Cardinal Road Reserve

Consultation summary report

Deb Piattoni Landscape Architect
Open Space Design & Development Unit
July 2021

Moreland
City Council

Final Concept Plan for Cardinal Road Reserve.

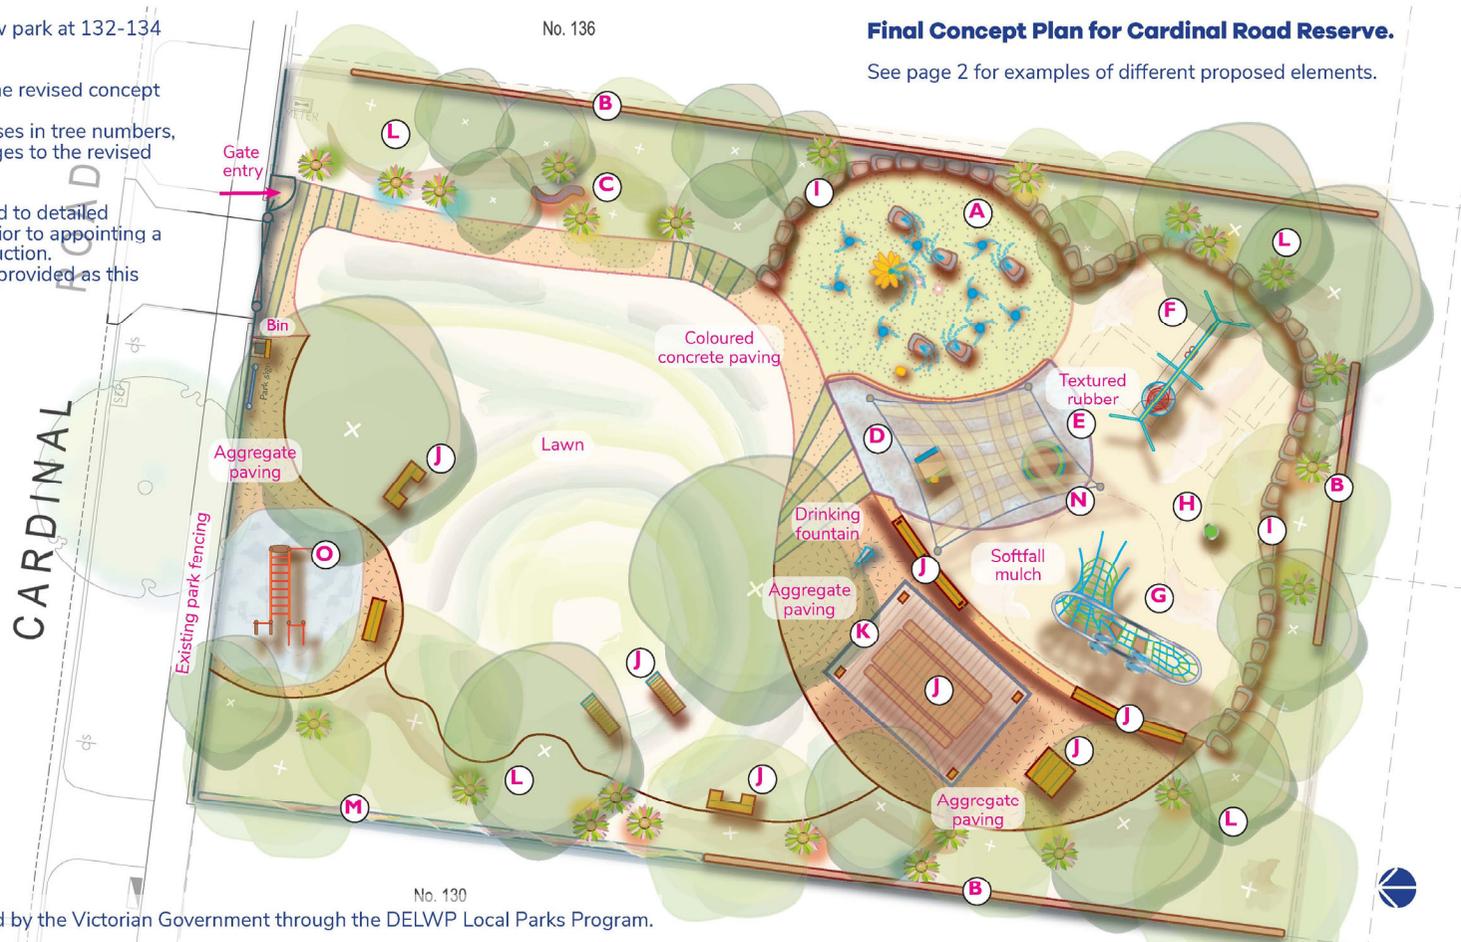
The online consultation event included two attendees, one of whom was querying how waste and litter will be managed at the new park. Neither attendees have asked for further changes to the revised concept plan. The only other change to the final concept plan is increased number of trees provided.

This final plan reflects the revised concept plan. Aside from some increases in tree numbers, there are no other changes to the revised concept plan.
